Contract #: 04-0120F4Cty: SF/ALA Rte: 80 PM: 13.2/13.9File #: 69.25B**QUALITY ASSURANCE -- NON-CONFORMANCE REPORT****Location:** Changxing Island, Shanghai, PRC**Report No:** NCR-000256**Prime Contractor:** American Bridge/Fluor Enterprises, a JV**Date:** 21-Apr-2009**Submitting Contractor:** Zhenhua Port Machinery Company, Ltd (ZPMC), Changxing Island**NCR #:** ZPMC-0230**Type of problem:**

Reference Description: Continuity Plate Retrofit, Doubler Plate Fit-Up**Description of Non-Conformance:**

Subject: NCR No. ZPMC-0230

Joint fit-up **Coating** **Other** **Component:** OBG Segment 2AW

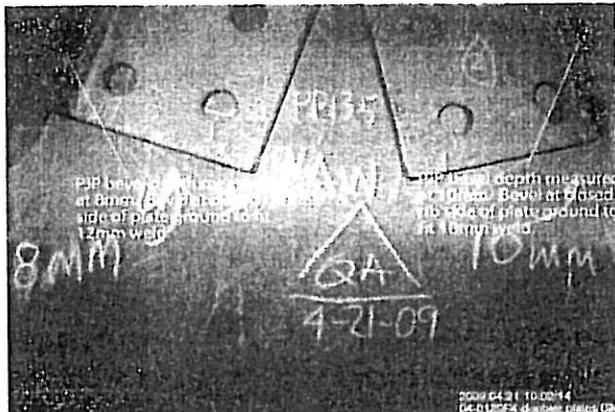
The following issues were found regarding the fit-up of the continuity plate retrofit doubler plates in OBG Segment 2AW:

- 1) The doubler plates were fit up without sufficient depth for the PJP weld.
- 2) Closed rib to diaphragm welds were not ground to 8mm as required for proper fit-up.
- 3) The doubler plates were fit up with excessive gap (3mm) to the diaphragm plate and the closed rib to diaphragm welds.

Joint survey was performed with CT and ABF. Welds were ground down, root gap issue was addressed, and shims will be used where gap is out of tolerance for bolting.
